RSN: 1881854 | PERMIT#: 25-2513934-CM

City of Aurora Building Division
Reviewed for Code Compliance
Approved as Noted: Robert Lowman
Date: May 06, 2025
2021 INTERNATIONAL CODES & 2023 NEC

1 SANITARY AND VENT RISER DIAGRAM SEGMENT A-D
SCALE:

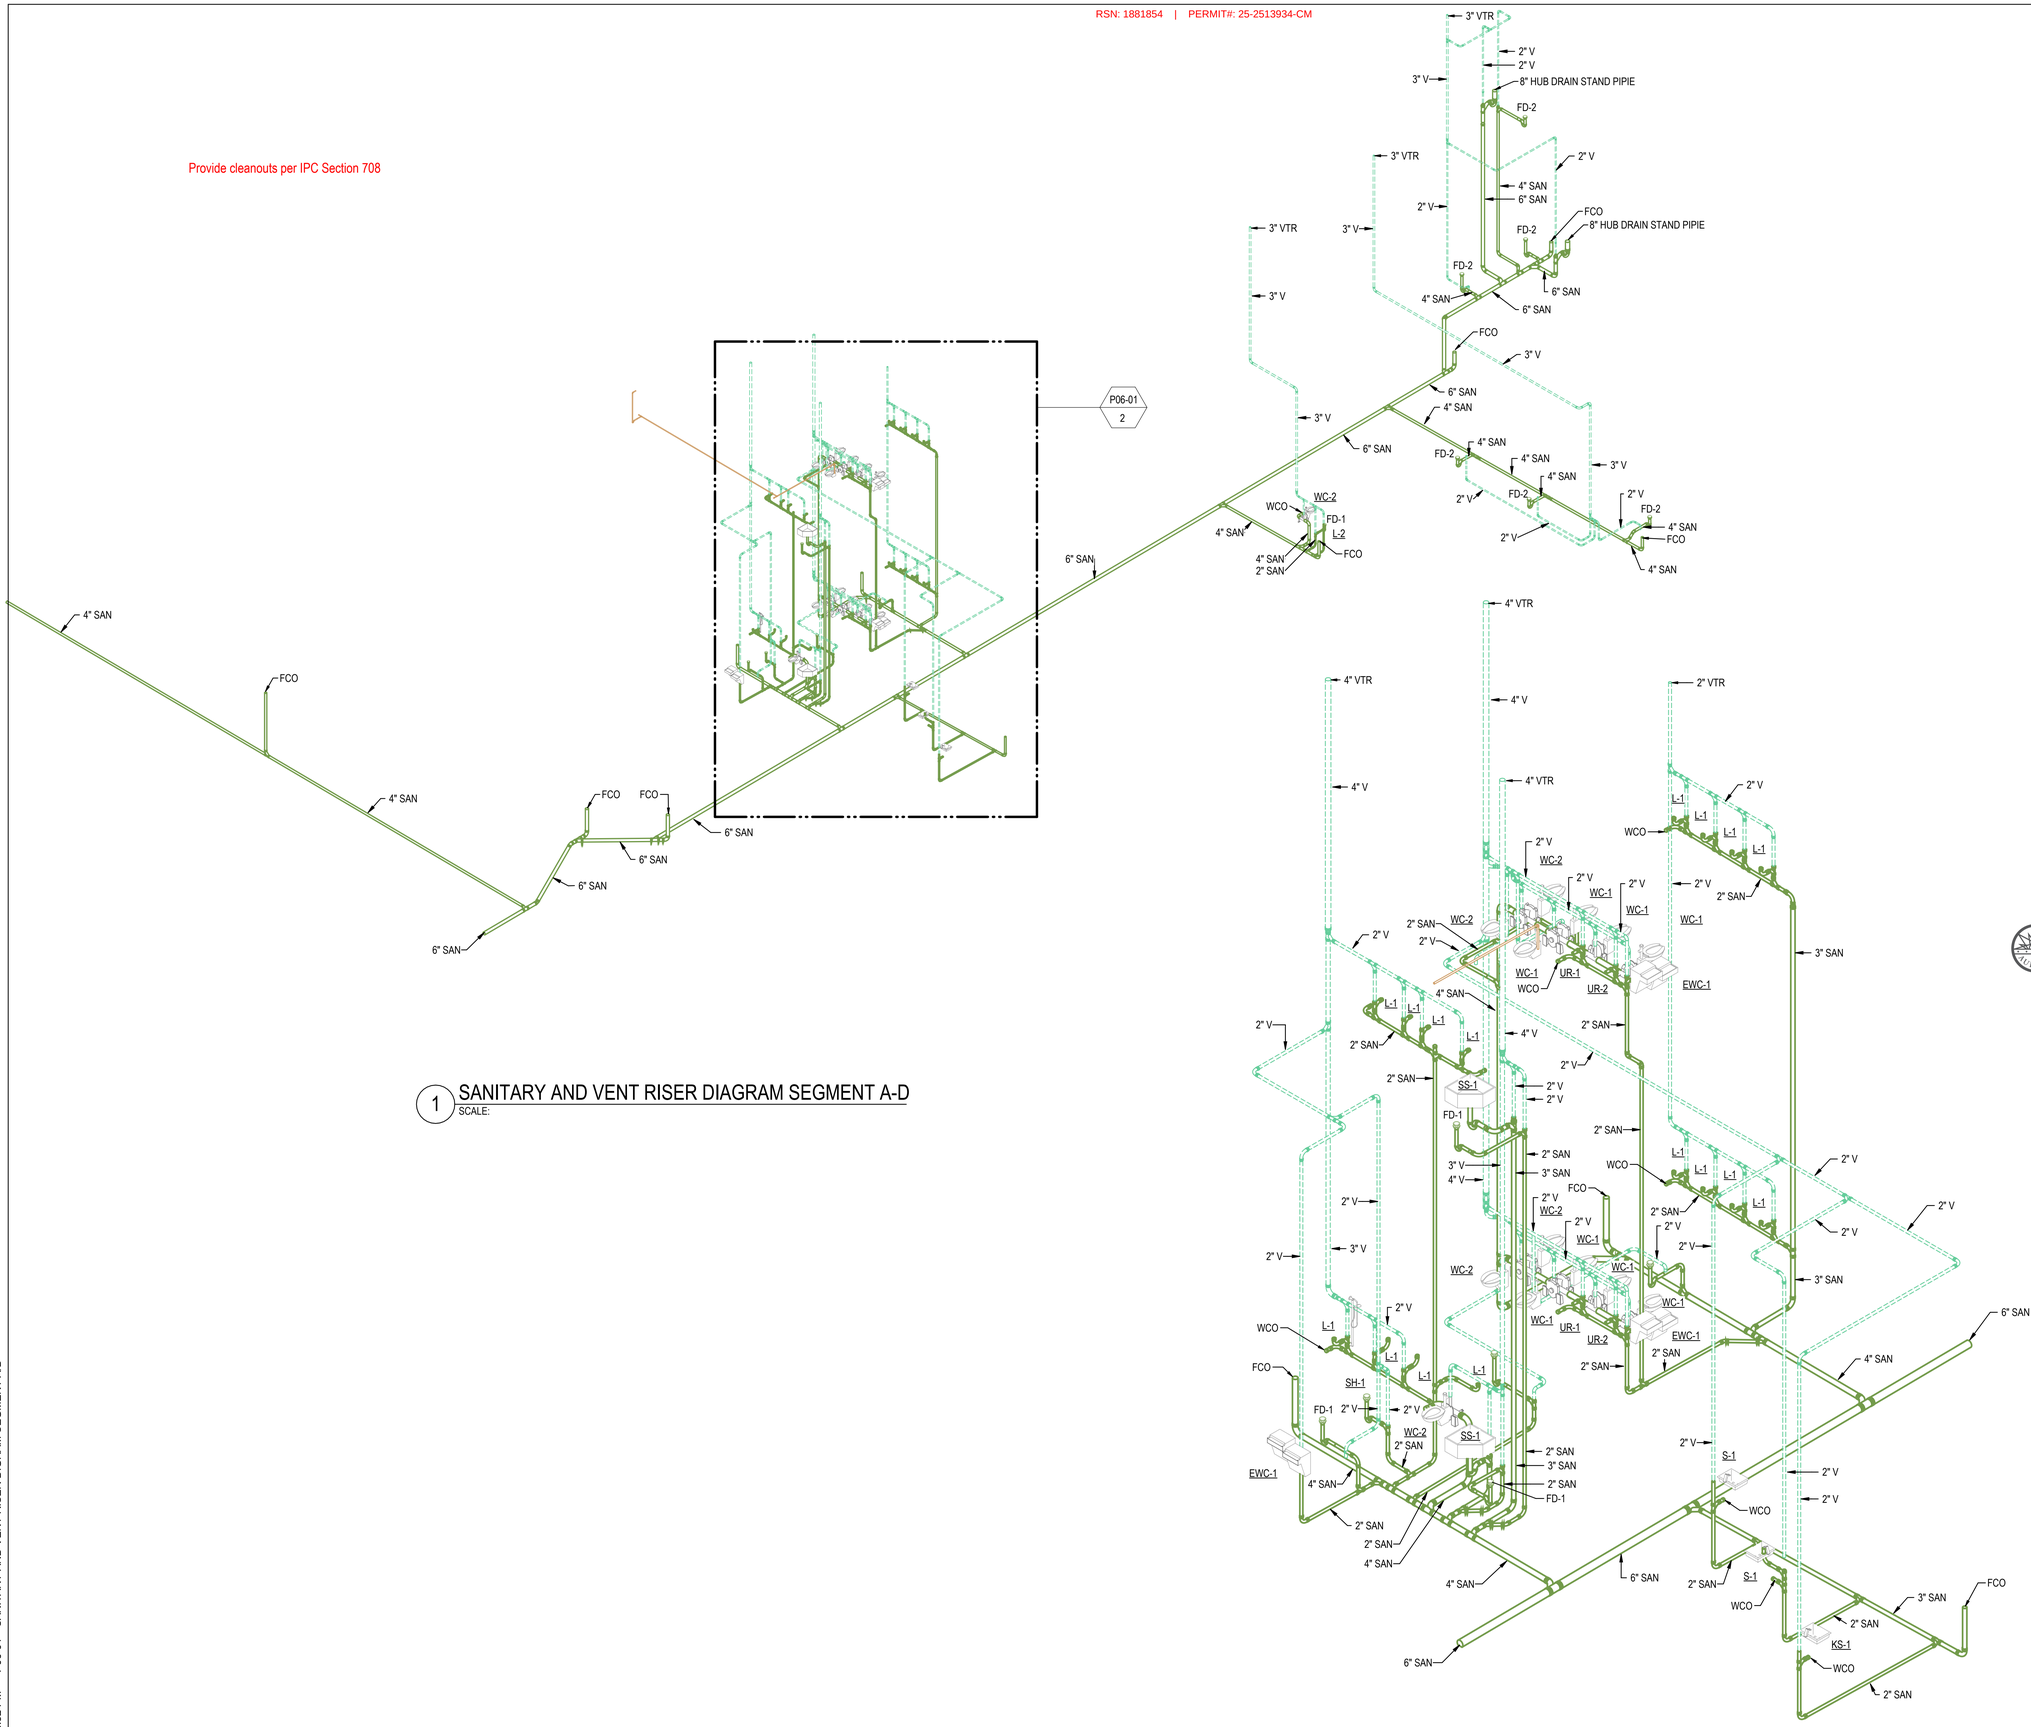
Provide cleanouts per IPC Section 708

2/4/2025 4:16:32 PM P06-01 SANITARY AND VENT RISER DIGRAM SEGMENT A/D

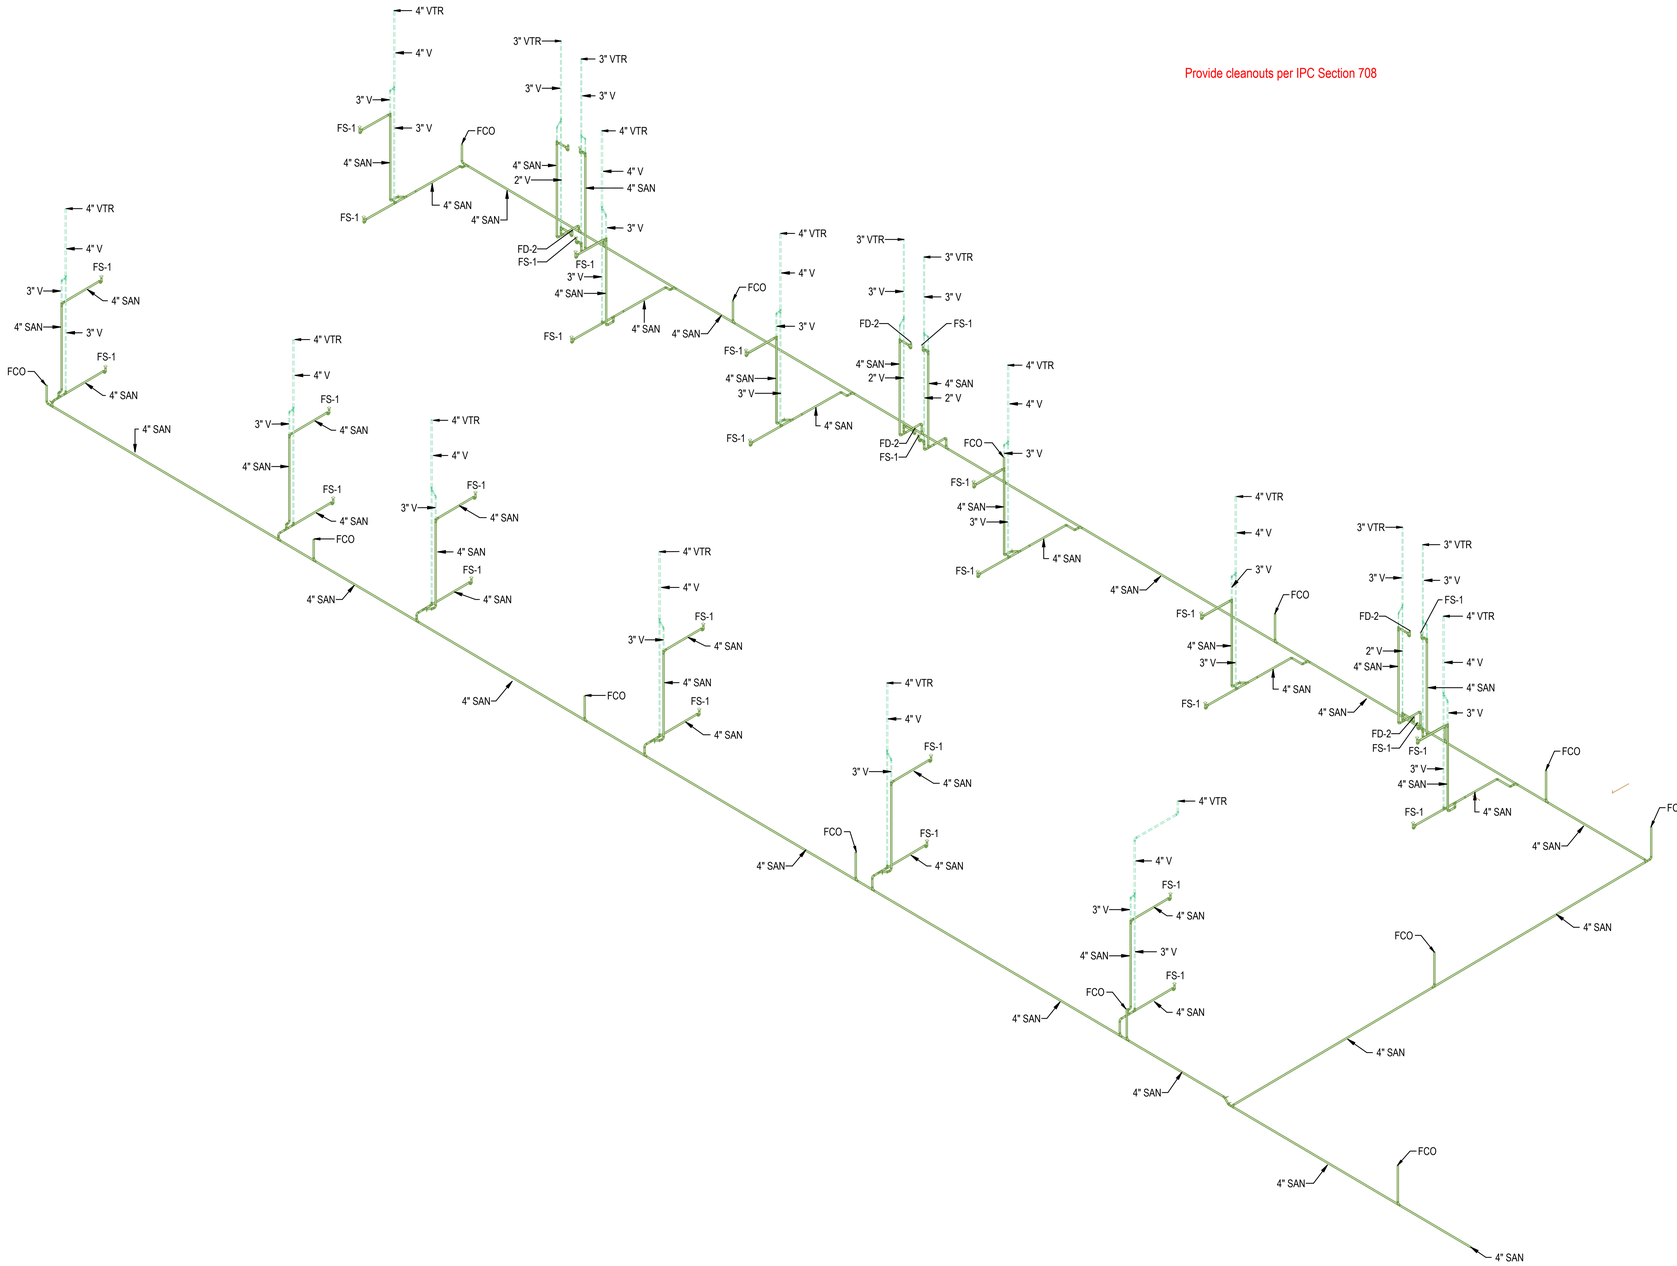
Provide cleanouts per IPC Section 708

2/4/2025 4:16:44 PM P06-02 SANITARY AND VENT RISER DIGRAM SEGMENT F/H

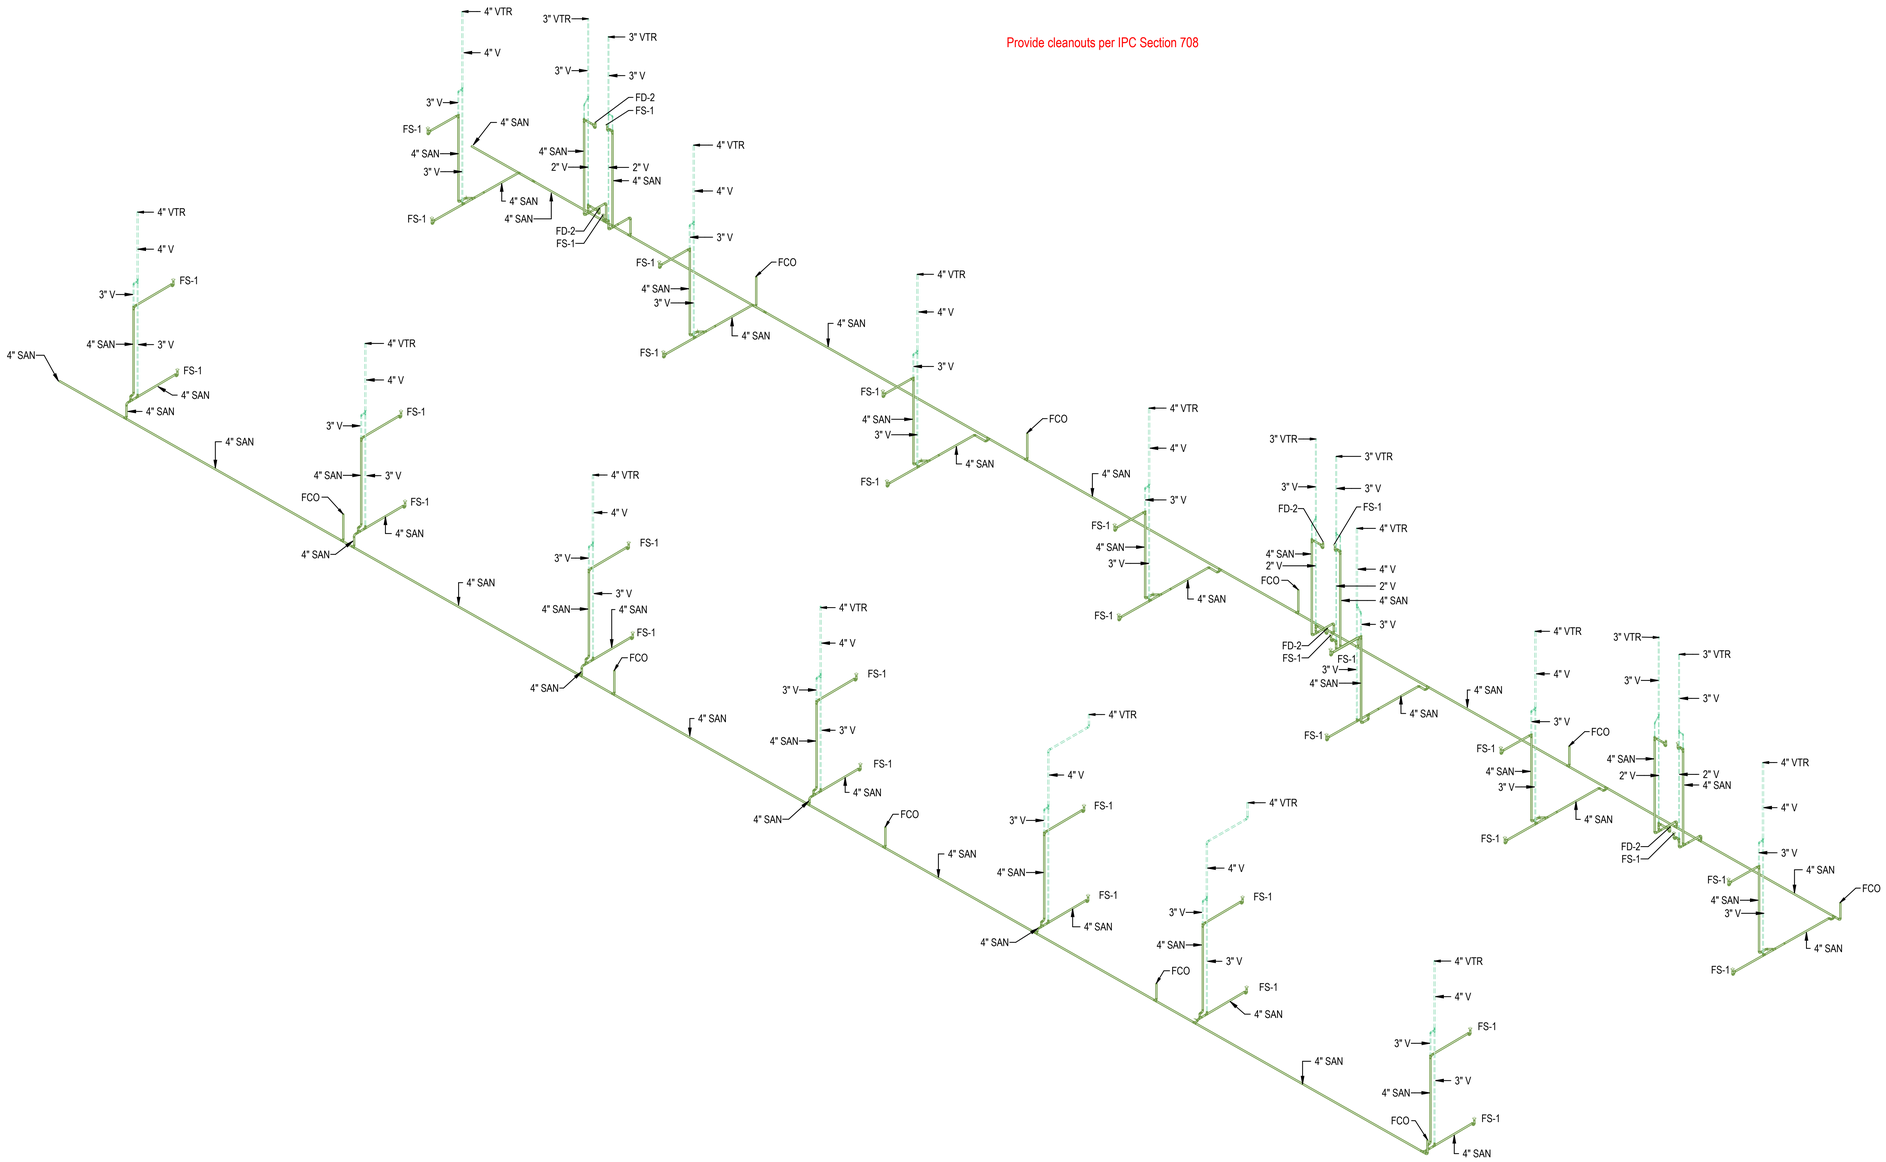
Provide cleanouts per IPC Section 708

2/4/2025 4:16:53 PM P06-03 SANITARY AND VENT RISER DIGRAM SEGMENT M/R

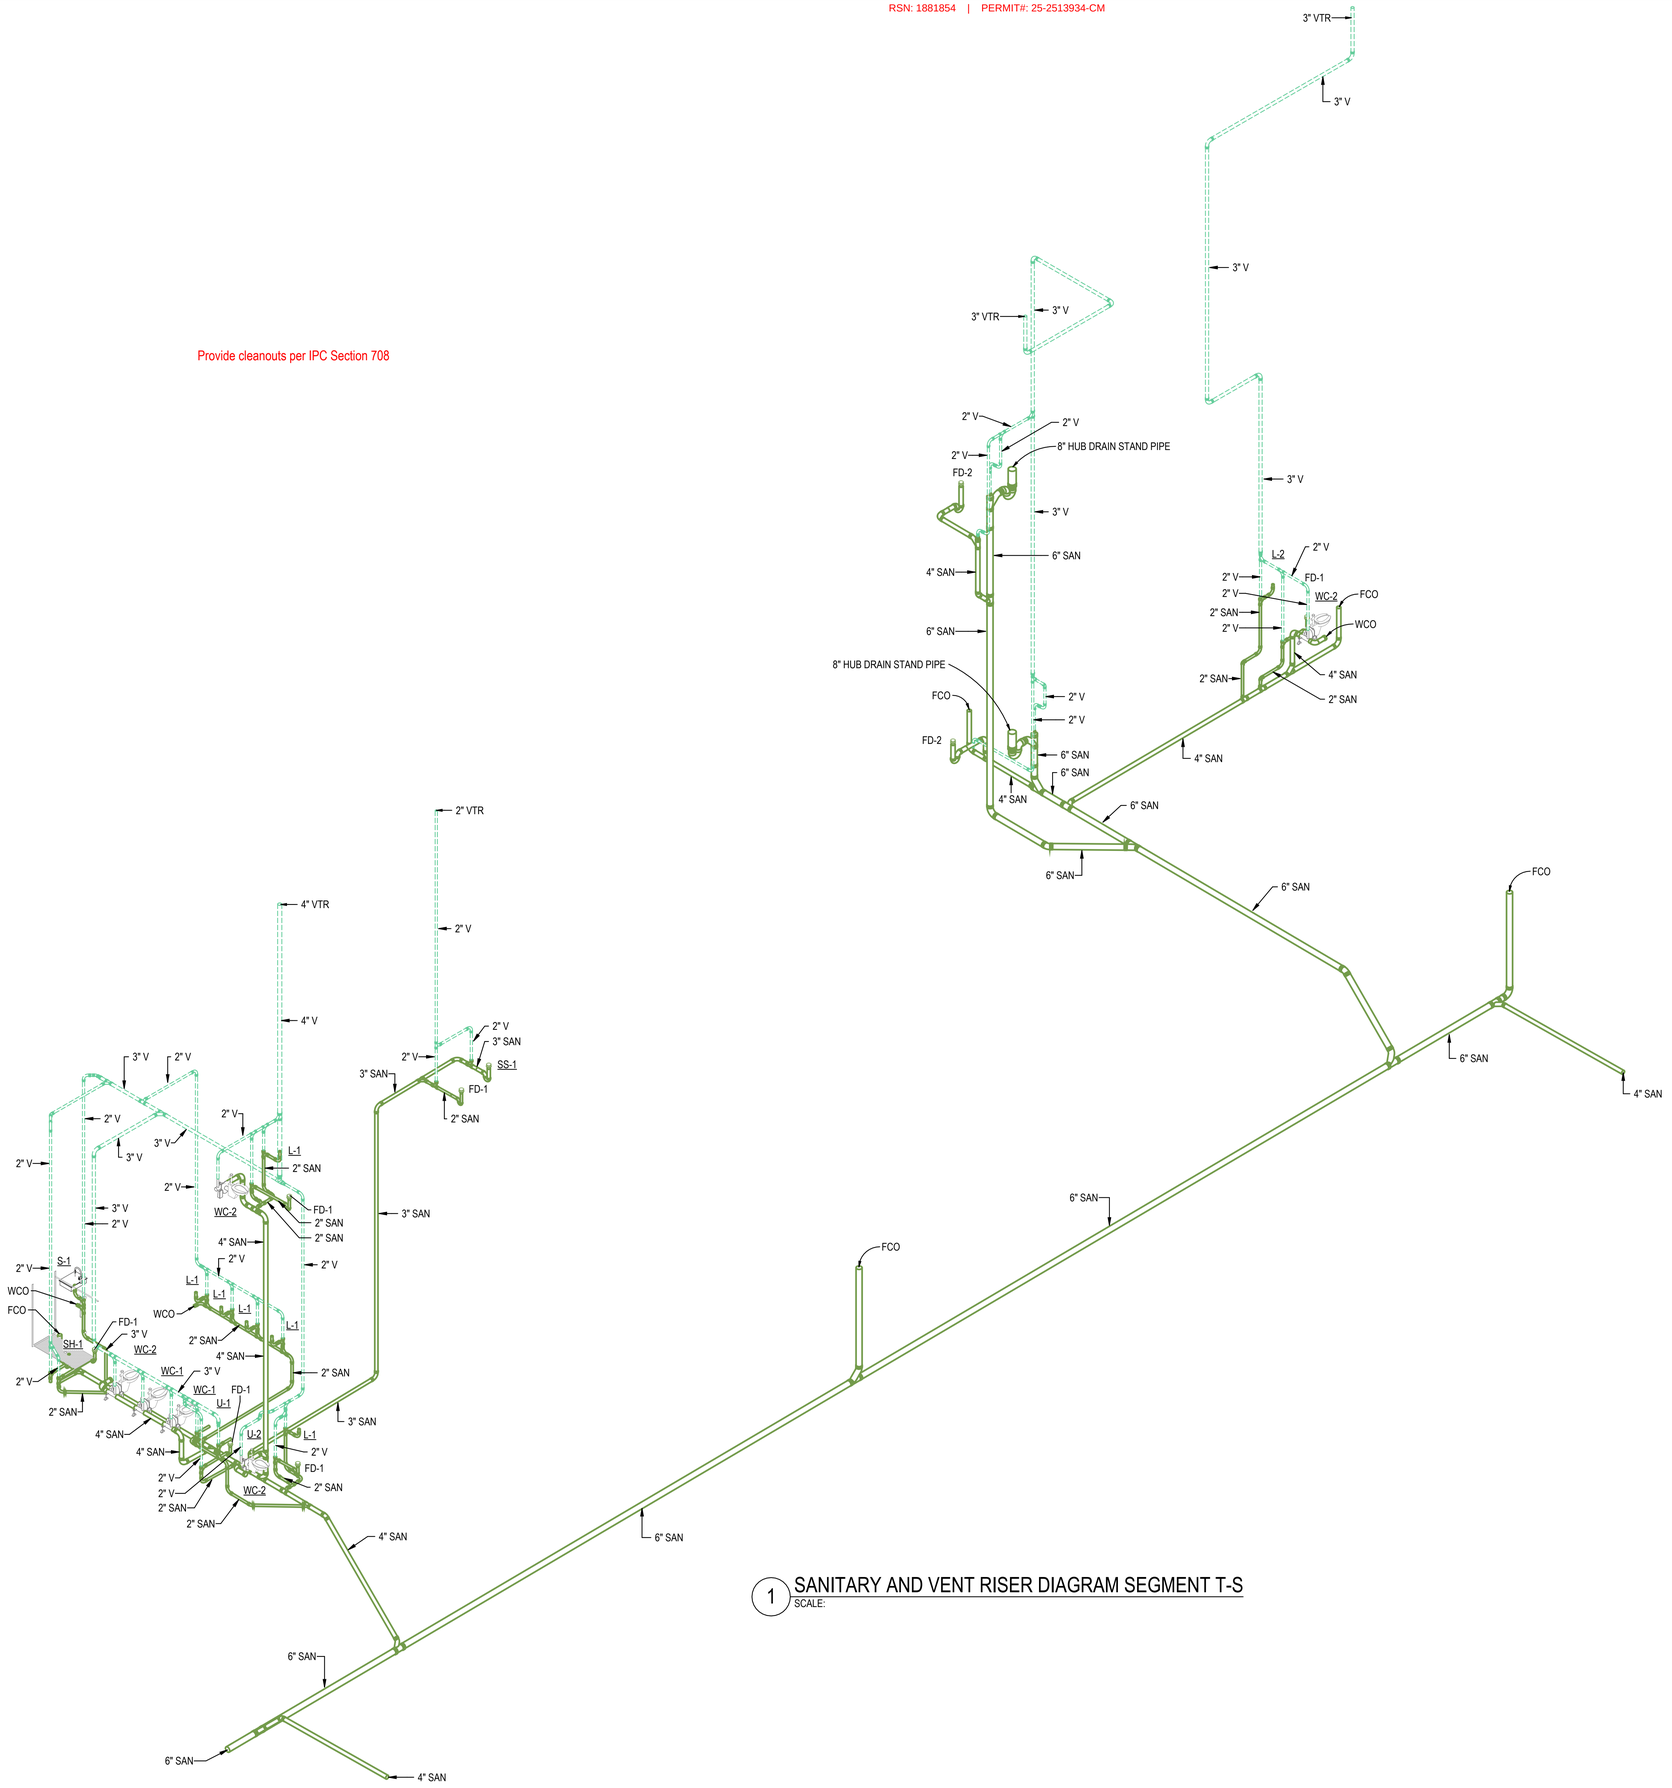
Provide cleanouts per IPC Section 708
